**ITEM 6. SECTION 96 MODIFICATION APPLICATION: 111-139  
DARLINGHURST ROAD AND 224-226 VICTORIA STREET POTTS  
POINT - FORMER CREST HOTEL**

**FILE NO: D/2013/1747/A**

**Proposal Summary:** Modification of the approved Stage 1 building envelope so as to accord with the competition winning design now lodged concurrently as a Stage 2 Development Application.

**Figure 14:** Amended envelope to Darlinghurst Road (east elevation). Approved Stage 1 envelope outlined in red. Proposed projections circled in black and shaded orange. Reduction to envelope shown at top of building and podium shaded pink.

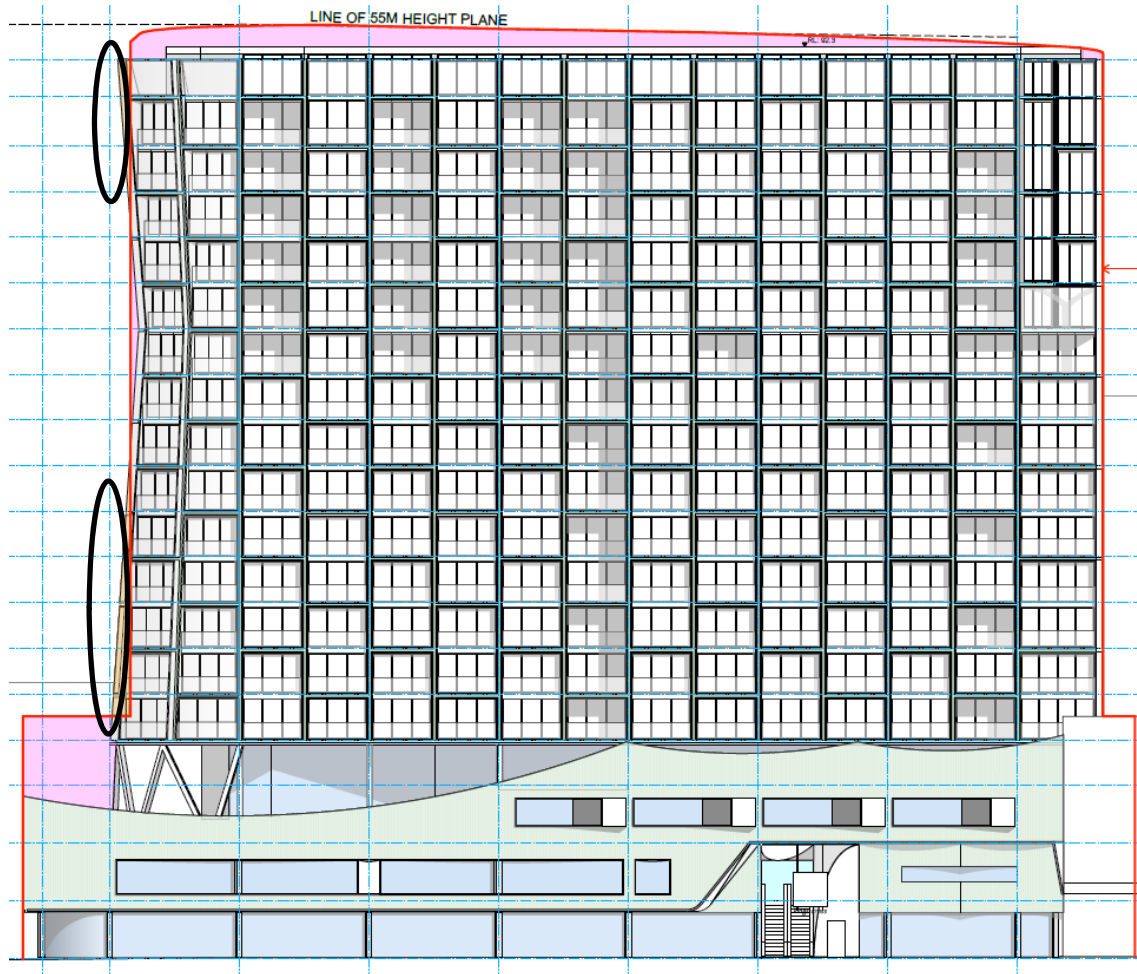
14. Consent is sought to modify the approved Stage 1 envelope, by increasing the building footprint mainly in the north-west corner of the tower. This is best represented by the 4 images below. The approved Stage 1 envelope is shown outlined in red, with the proposed projections outlined in black and shown with orange shading.
15. While there are some projections beyond the approved envelope, there are also some reductions in the envelope. The reductions can be seen mainly at the top of the tower and are shown in pink shading. The amended envelope will still comply with the 55 metre height limit.
16. The proposal also seeks to delete condition (10) which relates to site contamination investigations to be submitted with the Stage 2 Development Application.

**Figure 20:** Diagram showing the geometry of the Stage 2 proposal at various levels (shown in green, blue and pink outline) compared to the approved Stage 1 building envelope (shown in a black hatched line)

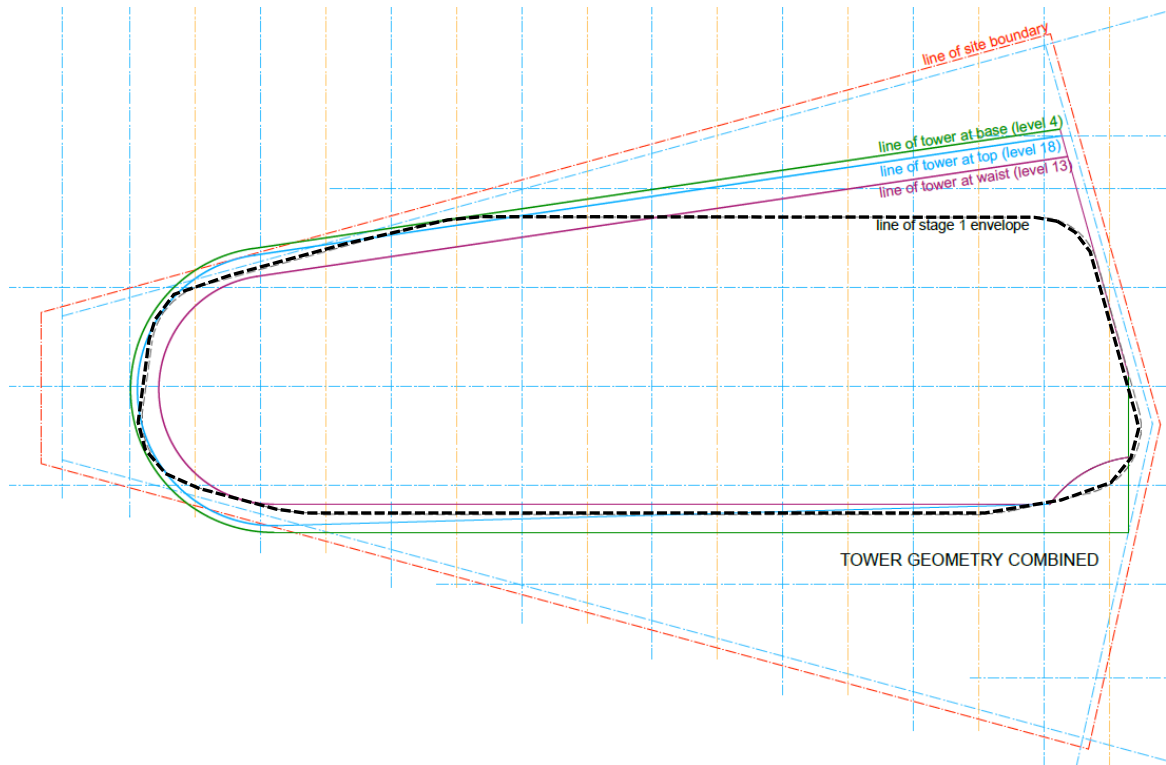
26. The proposal seeks to modify the approved building envelope and, as such, amended plans are necessary to reflect the desired changes.
27. The amended envelope is the result of a design competition undertaken in accordance with Clause 6.21(5) of Sydney LEP 2012 and the Stage 1 development consent.
28. The amended envelope does not result in any additional height. The maximum height of the amended envelope remains at 55m, which complies with the maximum building height permissible under Sydney LEP 2012, and in accordance with the Stage 1 development approval.
29. The amended envelope contains some projections beyond the approved envelope, which vary according to the level of the building, as shown in Figure 20 below. This corresponds with the tapered hourglass design of the winning competition entry by Durbach Block Jagers.

30. In terms of design, the proposed projections are acceptable. They vary at different levels, thereby retaining the tapered and hourglass form of the building. Therefore, the main consideration as to whether the changes are appropriate relate to considering any additional view loss and overshadowing.

**Figure 23:** View impact analysis from an apartment at 82-94 Darlinghurst Road showing that the proposal will not impact on views when compared to the approved Stage 1 building envelope

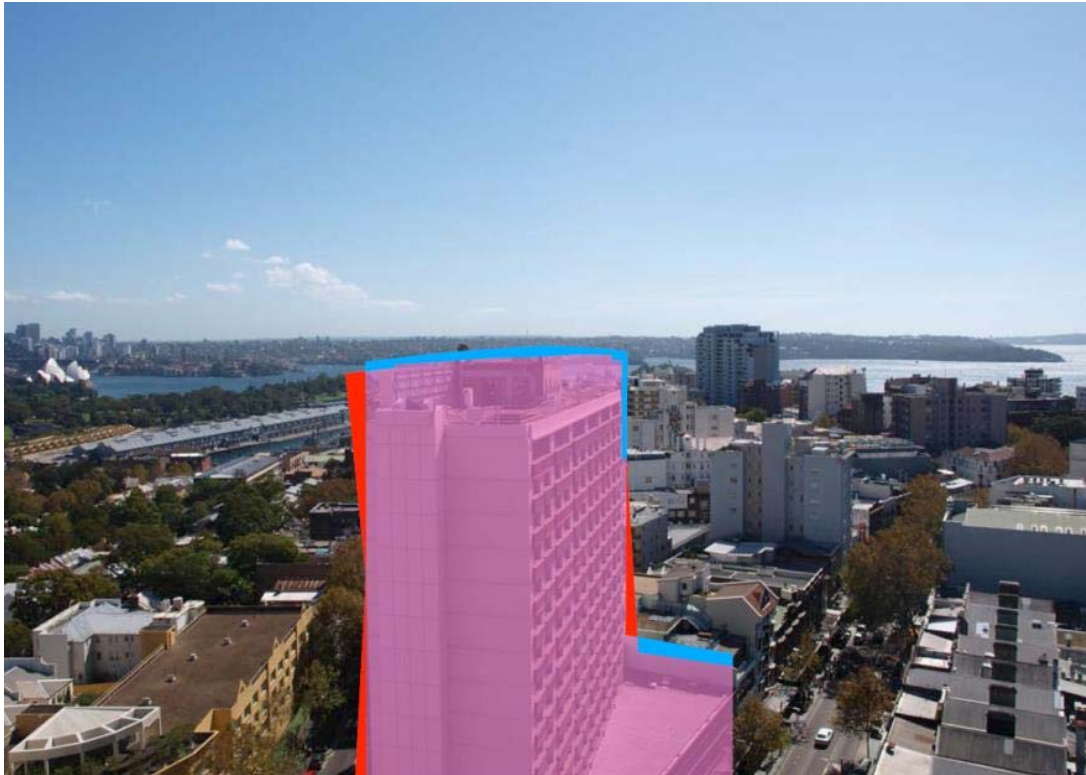
33. A view impact analysis was submitted with the current Stage 2 application, following the approach adopted for the Stage 1 view impact assessment.
34. Because the geometry of the Stage 2 tower differs from the approved Stage 1 envelope, the proposal actually results in a reduction in the extent of view loss from surrounding properties.
